Product Change Notice (PCN)

PCN Number: **PCN-0450890R-01**

Product(s) Affected: *SJ1-351X-SMT Series (SJ1-3513-SMT-TR, SJ1-3514-SMT-TR, SJ1-3515-SMT-TR, SJ1-3515-SMT-TR-BE, SJ1-3515-SMT-TR-GR, SJ1-3515-SMT-TR-PI)*

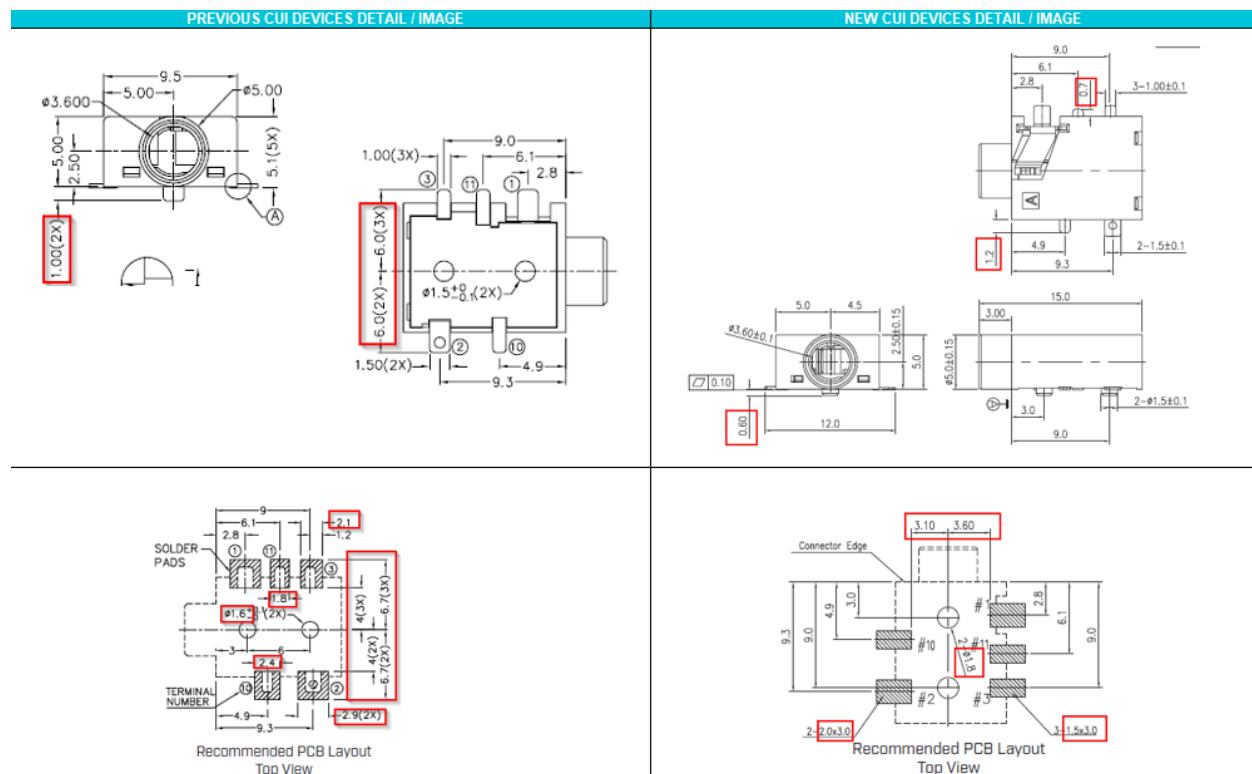
Description of Change: *Minor Housing and footprint differences. Material Change on the housing and terminals. See image Below*

PREVIOUS CUI DEVICES DETAIL / IMAGE			NEW CUI DEVICES DETAIL / IMAGE		
	MATERIAL	PLATING	DESCRIPTION	MATERIAL	PLATING/COLOR
terminal 1	copper alloy	gold flash	terminal 1	phosphor bronze t=0.30	gold flash over nickel
terminal 2	copper alloy	gold flash	terminal 2	phosphor bronze t=0.20	gold flash over nickel
terminal 3	copper alloy	gold flash	terminal 3	phosphor bronze t=0.20	gold flash over nickel
terminal 10	brass	gold flash	terminal 10	brass t=0.20	gold flash over nickel
terminal 11	brass	gold flash	terminal 11	brass t=0.20	gold flash over nickel
plastic	PA10T		cover	PAST [UL94V-0]	see color options
			housing	PAST [UL94V-0]	see color options
